MANDATORY
SERVICE BULLETIN

Service Bulletin No. 301B
(Supersedes Service Bulletin No. 301A)
Engineering Aspects are
FAA (DEER) Approved

SUBJECT: Maintenance Procedures and Service Limitations for Valves

MODELS AFFECTED: All Avco Lycoming opposed series aircraft engines.

Figure 1. Diagram of Valve Showing Area for Inspection

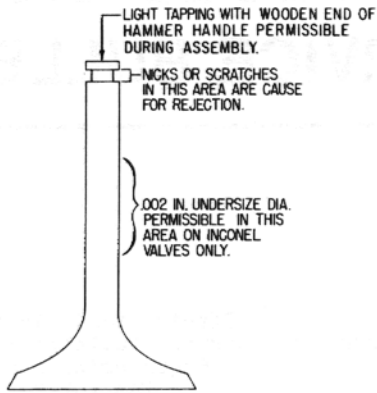
a. Remove valves from cylinder and clean to remove carbon and examine visually for physical damage, damage due to face burning or excessive corrosion in stem to head fillet area. Valves that indicate damage of this nature must not be reused. Do not reuse valves in which stem diameters midway of valve measure less than that measured at key end; excepting inconel valves which may be .002 undersize on stem diameter as shown in figure 1.

Figure 3. Section Thru Edge of Valve

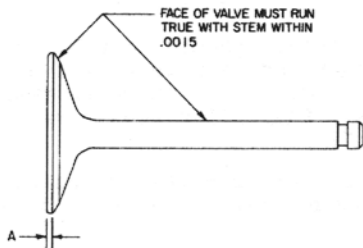
The edge of intake valve heads are generally formed as shown in figure 3. The thickness "A" can best be measured with an optical comparator; however, it can be measured with sufficient accuracy by means of a dial indicator and a surface plate, as shown in figure 4.
